**TUESDAY 19 AUGUST 2014.**

**Planning and Environment Committee Meeting No. 8/14**

<b>Item</b>		<b>Page</b>
1	CONFIRMATION OF MINUTES - Meeting held on 5 August 2014.....	1
2	157 QUARRY ROAD, RYDE. LOT 9 DP 20764. Local Development Application for new dual occupancy (attached) LDA2014/0128 .....	5
3	62 CONSTITUTION ROAD, MEADOWBANK - LOT C IN DP 27200 Development Application for the construction of a weather shelter structure over the public domain area (in front of 62 Constitution Road). LDA2014/0135 .....	42

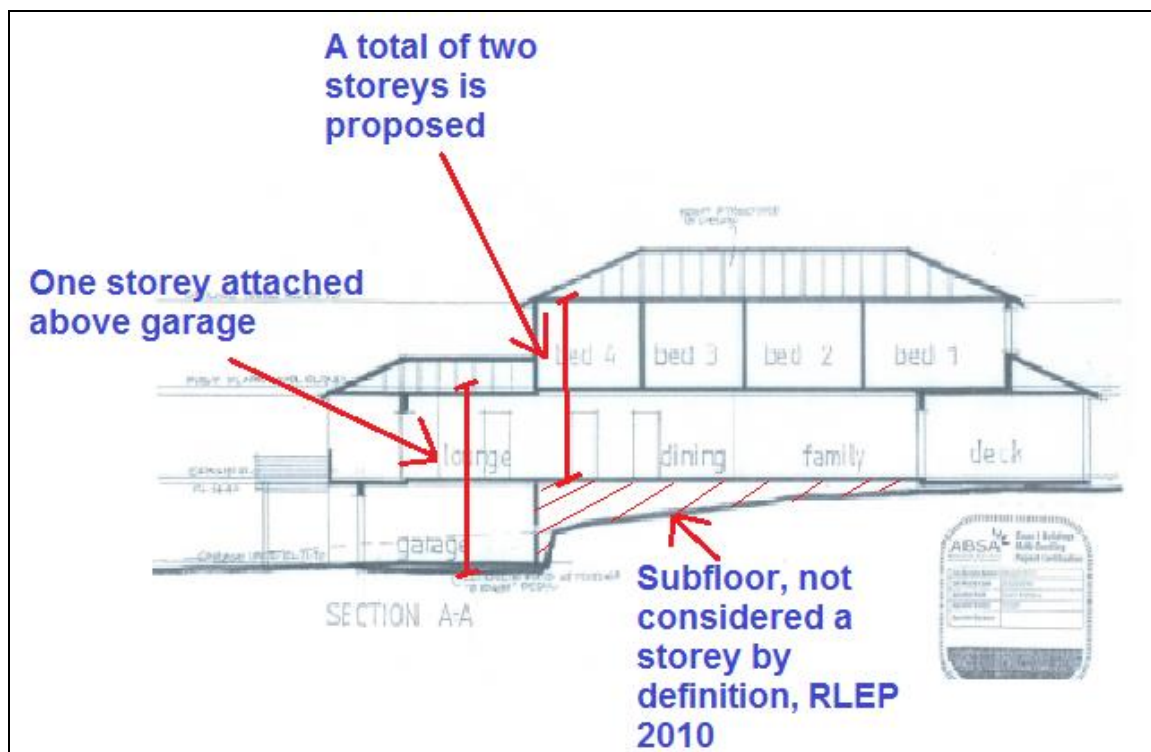
1. **Linear separation.** *The proposal does not comply with the Linear Separation requirements of DCP 2010 as there is an existing villa development at No 155 Quarry Road and the subject site is within twice the frontage of that site (ie immediately adjoining).*

Comment: As there is an existing multi-dwelling housing development immediately adjoining the site at 155 Quarry Road, this development does not comply with the linear separation controls.

Although the linear separation controls remain in Council's current DCP (Ryde DCP 2010), in March 2013 Council resolved to delete these controls and replace with an allotment width control for villa and dual occupancy developments when Draft LEP 2013 is gazetted. At the time of this report, this Draft LEP is currently awaiting gazettal in the Department of Planning, and so it is considered certain and imminent. When Draft LEP 2013 is formally gazetted, amendments to DCP 2010 will be made which include removal of the linear separation controls. Accordingly, whilst the linear separation controls remain in the DCP, and the DA does not comply with these controls, no planning

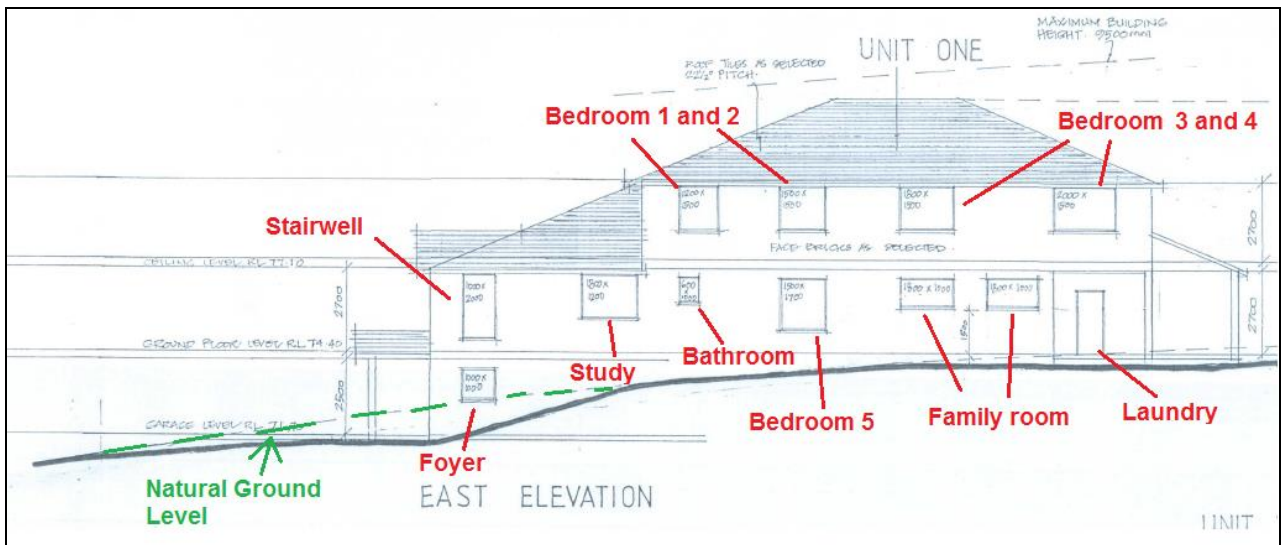
3. ***Privacy and Overlooking Impacts.*** *Concerns are raised that the proposed development will reduce the level of privacy to the adjoining villa development at No 155 Quarry Road. In particular, concerns are raised that the east and north-facing windows will enable direct overlooking of the courtyard areas and internal living areas (dining rooms, kitchen and bedrooms) of the adjoining villas at No 155 Quarry Road to the east. Concerns are also raised regarding overlooking impacts from the proposed balconies at the rear (1<sup>st</sup> floor) and front (ground floor) of the development.*

Comment: The east-facing windows of the development relate to unit 1 of the development – and is shown in the east elevation drawing below. The DA plans show that the upper storey of the development (first floor level) consists only of (4) bedrooms facing towards the objectors' property. These rooms are used infrequently and predominantly at night and they are not considered to be primary living areas of the dual occupancy unit. As noted in Ryde DCP 2010, overlooking from bedroom windows is less of a concern than overlooking from the windows of other habitable rooms, because of the nature of use of these rooms.

The ground floor of unit 1 has a range of different types of rooms facing the objector's property. As shown on the east elevation drawing below, the rear of the development on the eastern side contains a family room which is to be provided with two "highlight" (1.5m sill height) windows because this room is one of the main living rooms of the development. Although the family room (of both units) is also to be provided with a sliding door window to the northern elevation, direct overlooking of the adjoining villas will be adequately resolved via boundary fencing given that the floor levels of this room are proposed to be at (or slightly below) natural ground level.

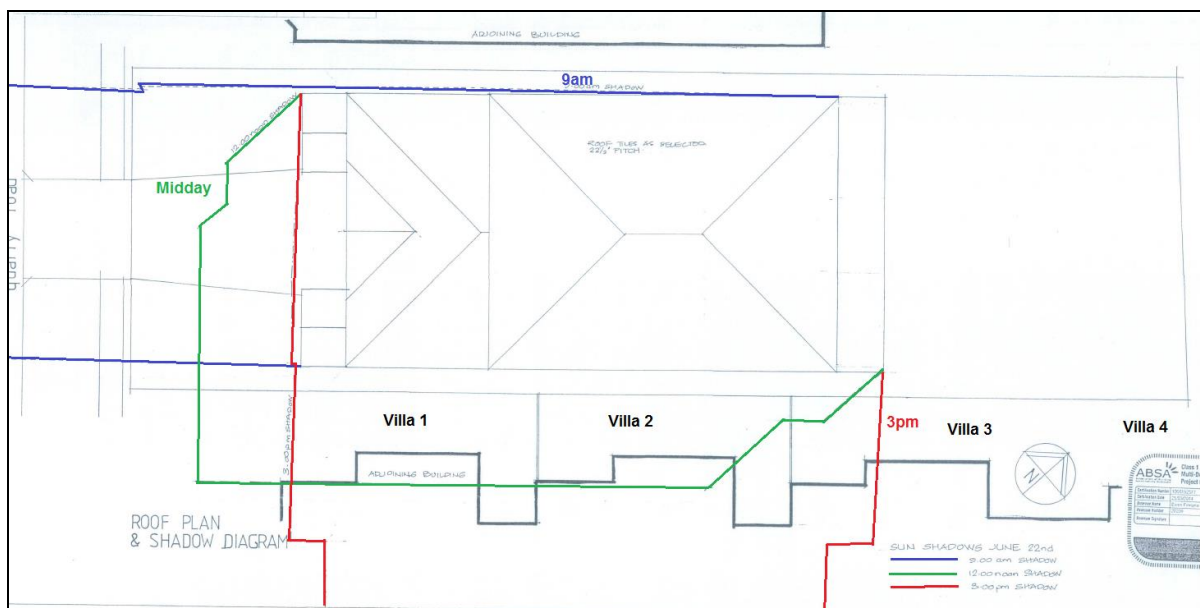
As demonstrated in the shadow diagrams submitted as part of the development application (see below), the proposed development will have some overshadowing impacts on the neighbouring villas at No.155 Quarry Road.

Villas 3 and 4 will continue to receive sunlight to at least 50% of the principal area of ground level private open space, ie the courtyards for more than two hours between 9am and 3pm on June 21, complying with Ryde DCP 2010.

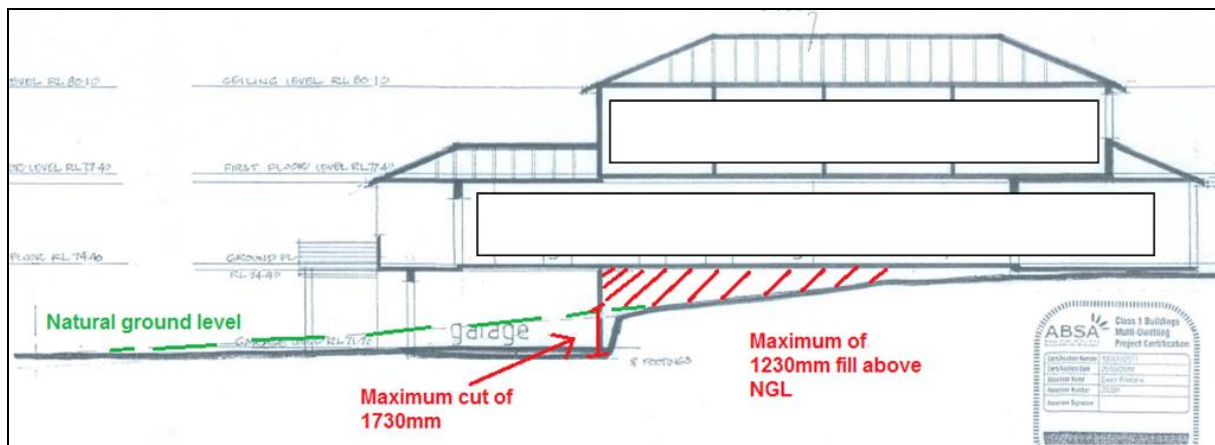
Section 2.5.2 of Part 3.3 of the Ryde DCP 2010 prescribes development controls for topography and excavation. Specifically, the Ryde DCP 2010 stipulates that:

- *Areas under the dwelling footprint may be excavated and filled so long as the maximum depth of excavation is limited to 1.2 metres and the height of fill is 900mm;*

- Areas outside the dwelling footprint may be filled so long as the height of fill is not more than 500mm; and
- The maximum height of retaining walls is no greater than 900mm.

- The cut exceedence within the building footprint is primarily concentrated in the front section of the eastern and western elevation– associated with the proposed single car garages.
- The fill exceedence within the building footprint is limited to a section below the ground floor lounge/study.
- The finished floor level of the ground floor will be lower than that of the existing dwelling on site and is up to 400mm below natural ground level towards the rear of the development, reducing the privacy impacts.
- The level of fill does not create excessive bulk and scale of the dwelling.
- The dwelling has a fully compliant overall building height and wall plate height.

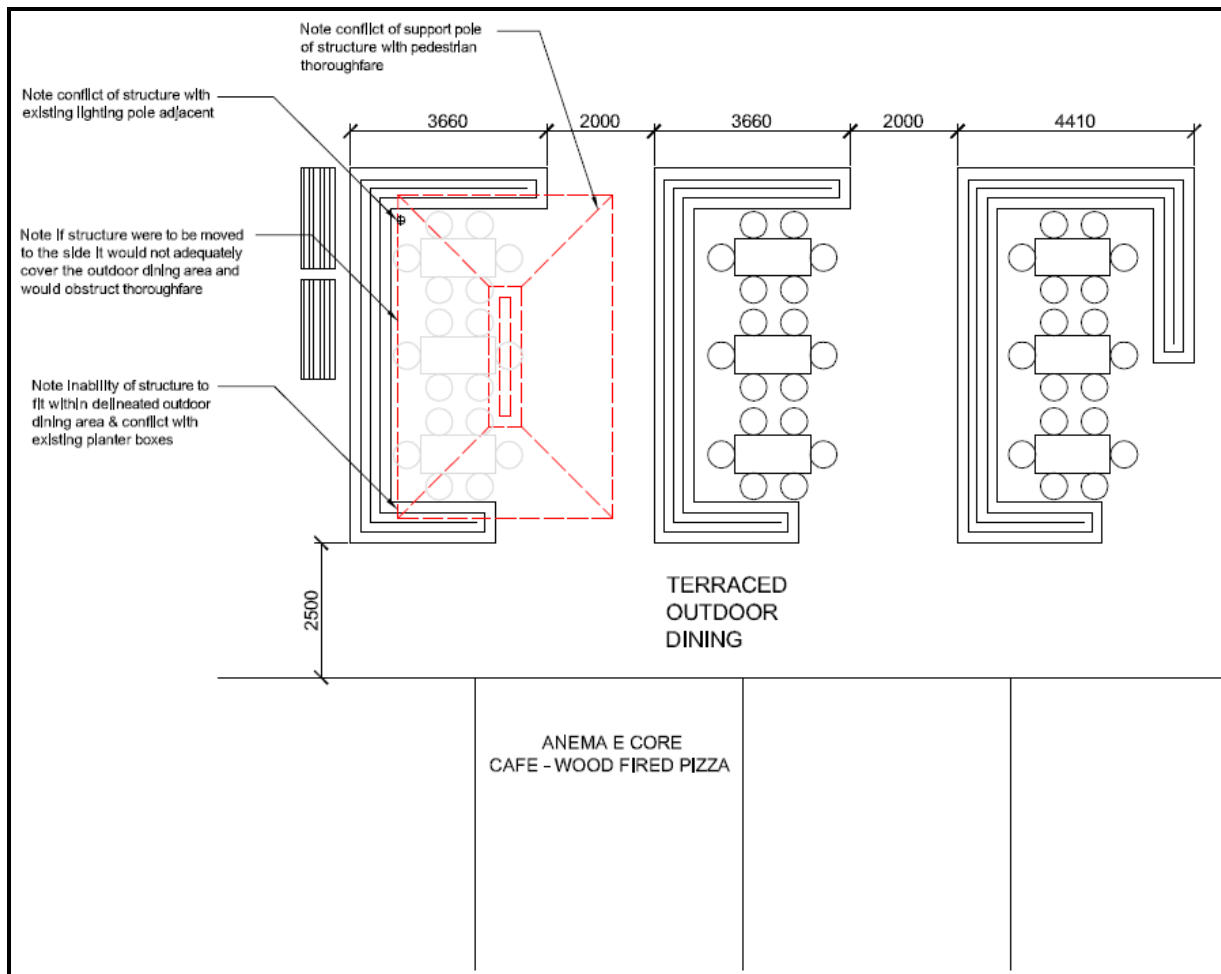
As demonstrated in **Figure 4** below, the proposed structure extends beyond the designated outdoor dining area into the 2m wide pedestrian thoroughfare, therefore failing to provide the minimum 2 metres clearance as required. As such, this cannot be supported for the following reasons:

A review of the plans submitted, and as indicated in **Figure 4** above, has revealed the proposed structure extends significantly beyond the designated outdoor dining area into the 2m wide pedestrian thoroughfare corridor. As noted within the above non-compliance, this is considered to significantly impact the safety, accessibility and circulation of this area of the public domain.

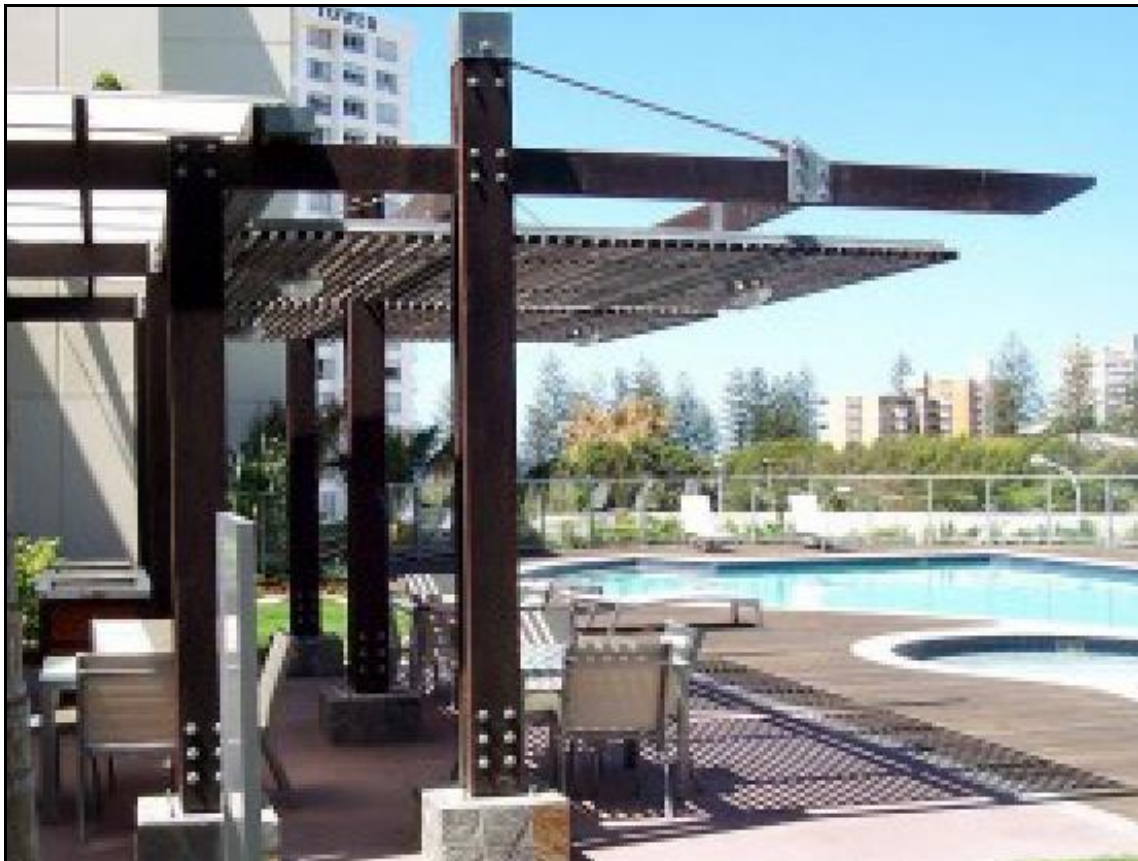
*The plaza was upgraded by Council in 2009/2010. The upgrade utilises a contemporary design with high quality materials and finishes. The recent upgrade of Meadowbank Station is also a contemporary design. The plaza and station complement each other using a similar design language. The recent upgrade can be regarded as a success as it manages to accommodate the movement of vehicles and people, and provides an appropriate setting for the social interaction which occurs within the three stepped terraces in front of the shops.*

*The proposed structure would introduce a discordant element within the plaza as it is not of the same style or quality as other streetscape elements. Further, the dimensions of the proposed structure are such that it is too large to fit within the terrace area. Hence the proposed structure is not supported.*

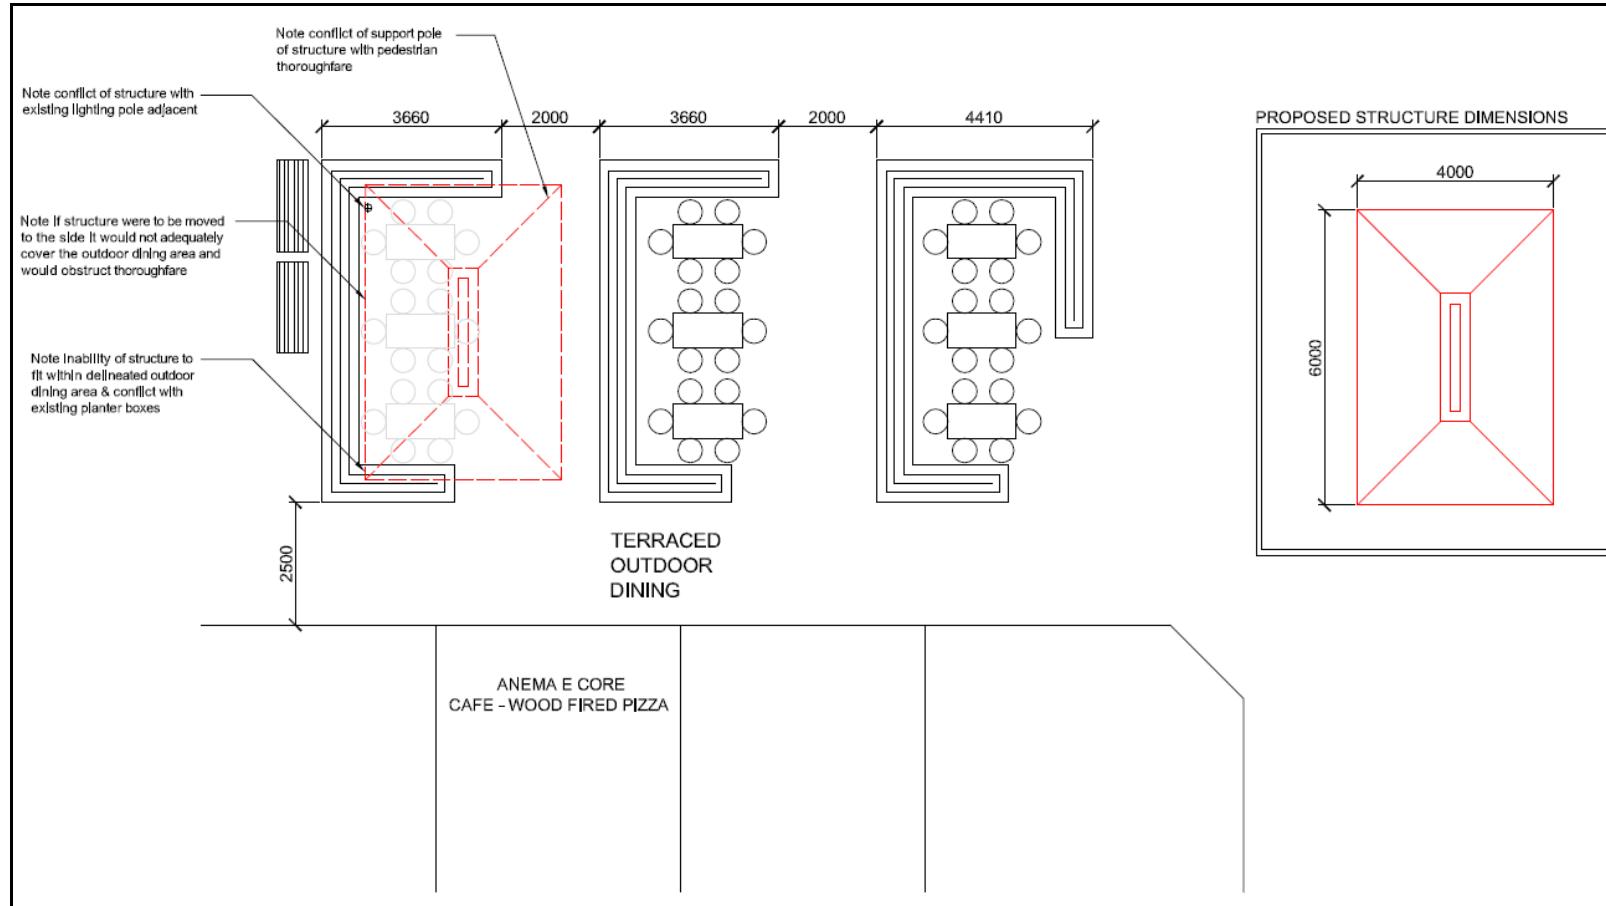
- Min. 2m wide pedestrian corridor	The proposal is not an application for a new outdoor dining area, but rather a structure located over an existing approved open-air outdoor dining. As demonstrated in <b>Figure 1</b> in the Attachment to this Compliance Table, the proposed structure extends beyond the designated outdoor dining area into the 2m wide pedestrian thoroughfare corridor and would inhibit the movement of pedestrians through this corridor by virtue of the support posts of the structure.	No
